Transportation Memorandum and
LADOT Approval

MEMORANDUM

RE: Design of Sunset & Beaudry
1111 Sunset Mixed-Use Project

WB-40 TURNING TEMPLATE
NO SCALE

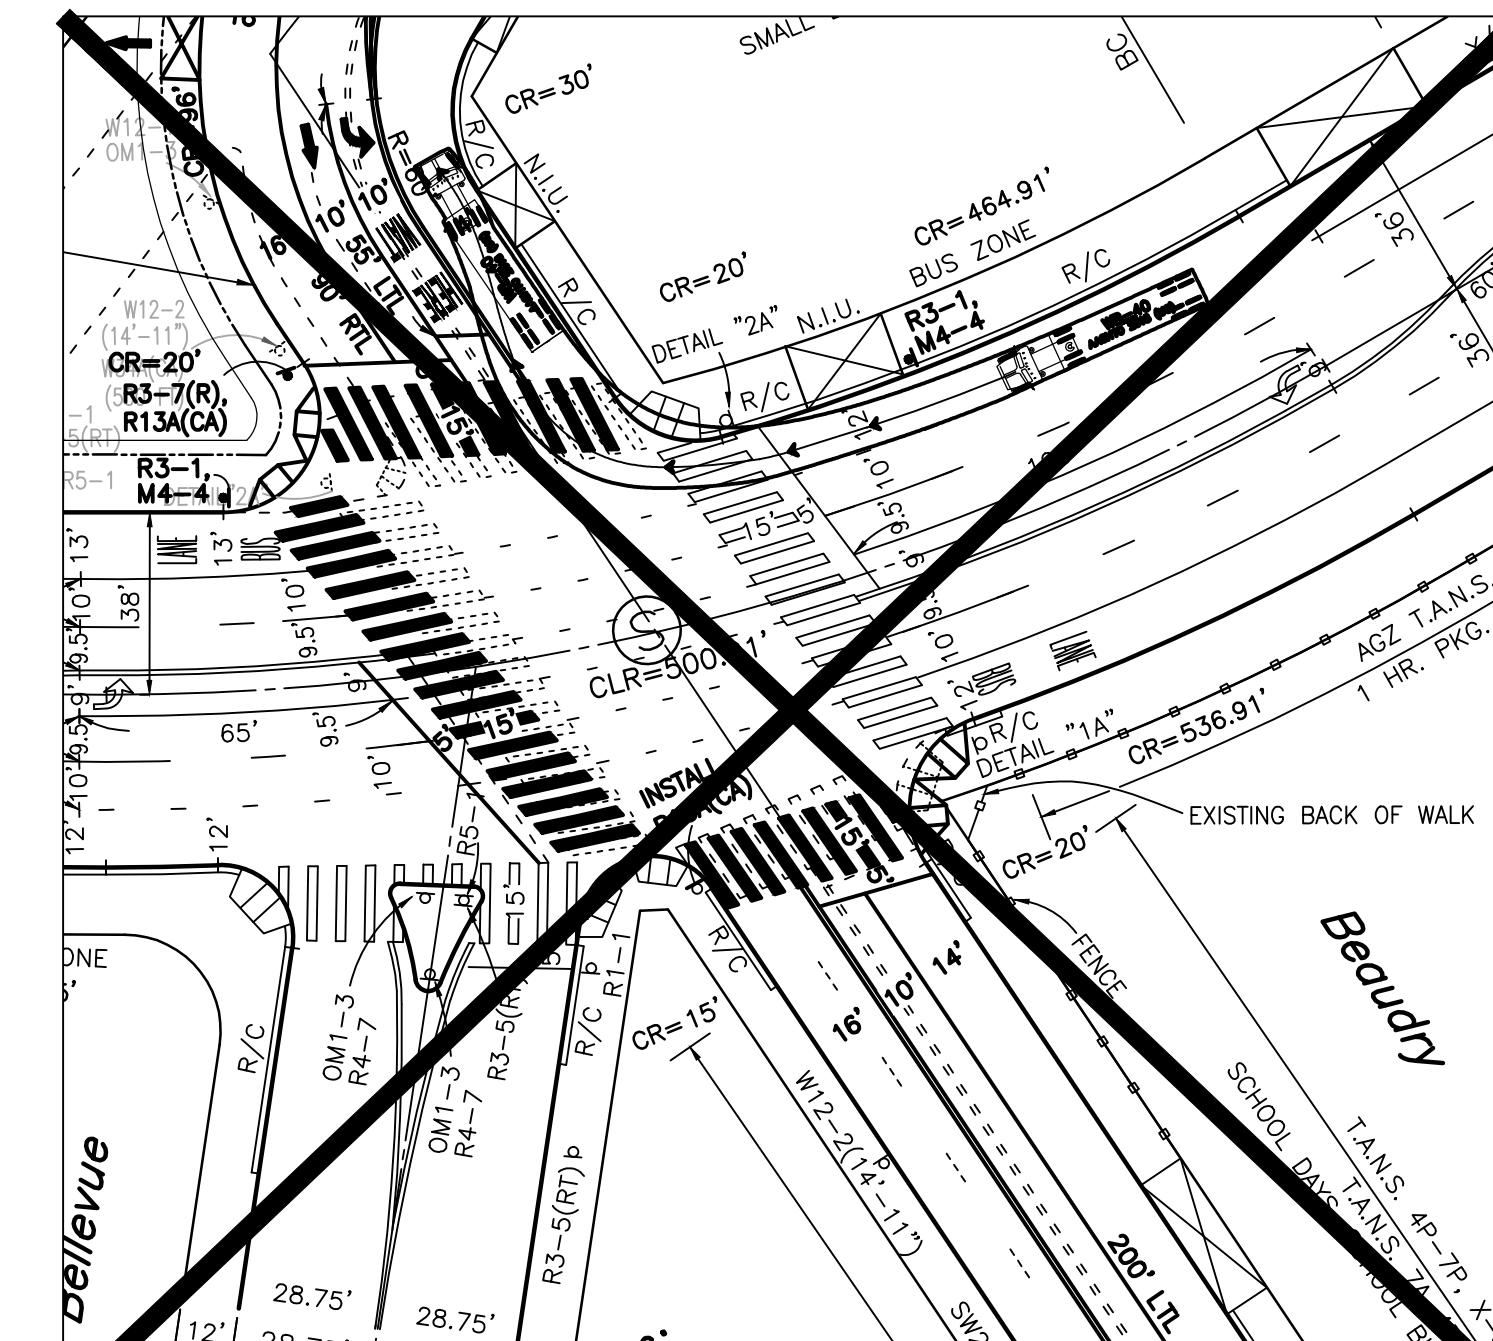
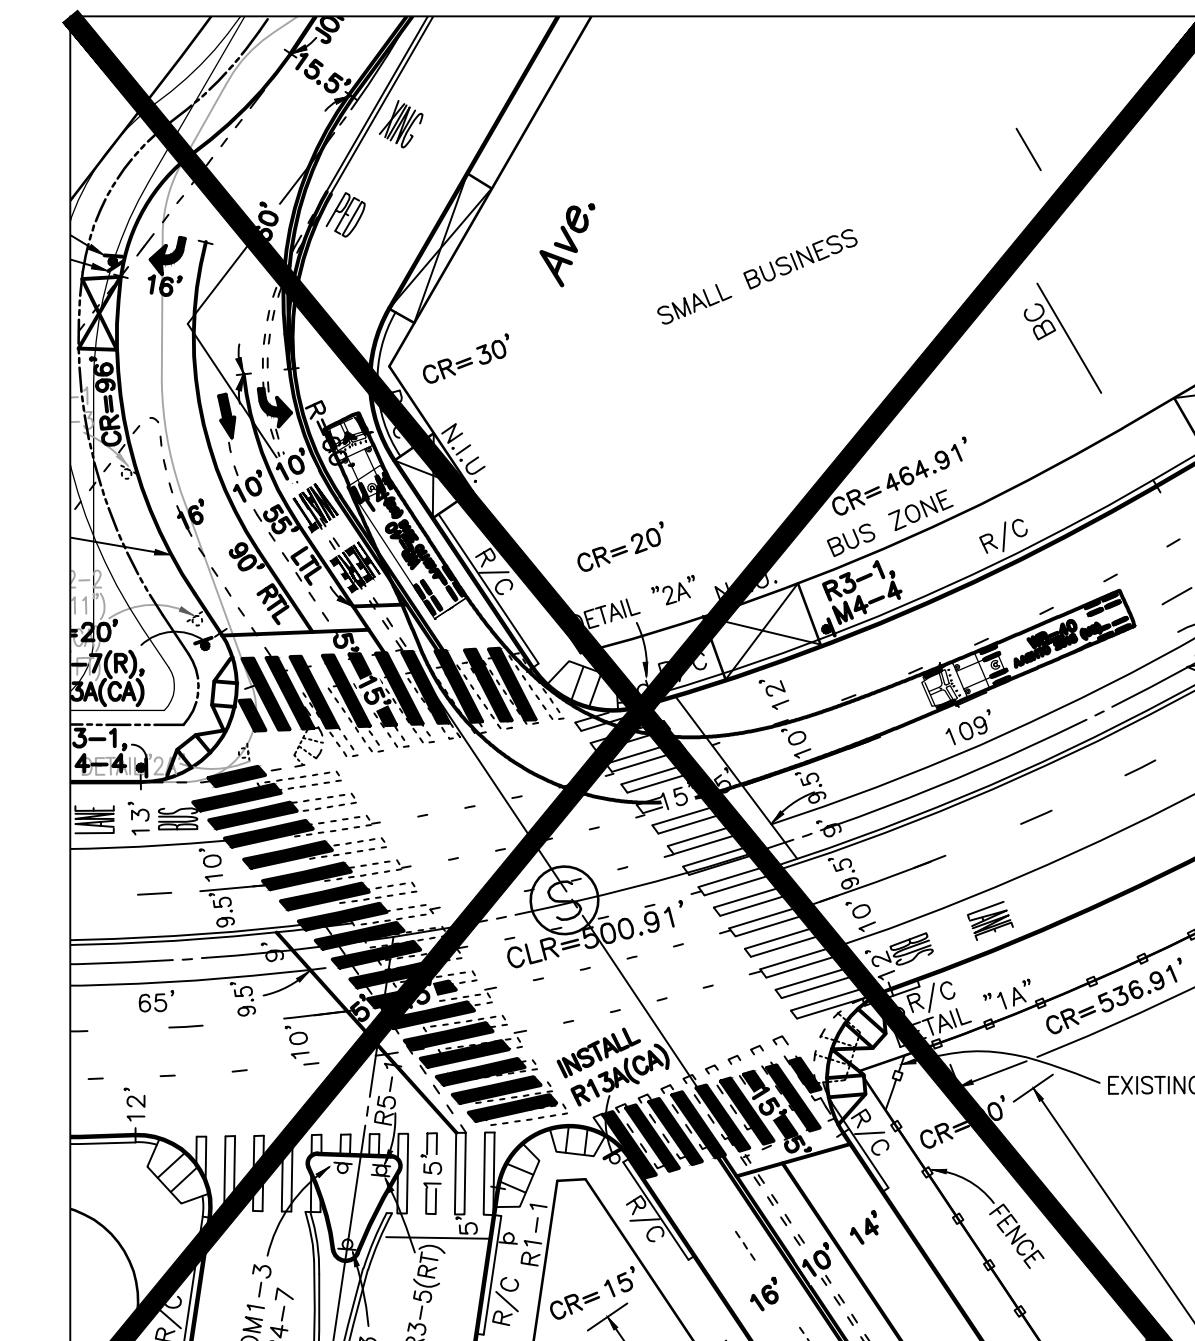
Figures 1B and 1C show the tests of the truck turning movements from each leg of the intersection.
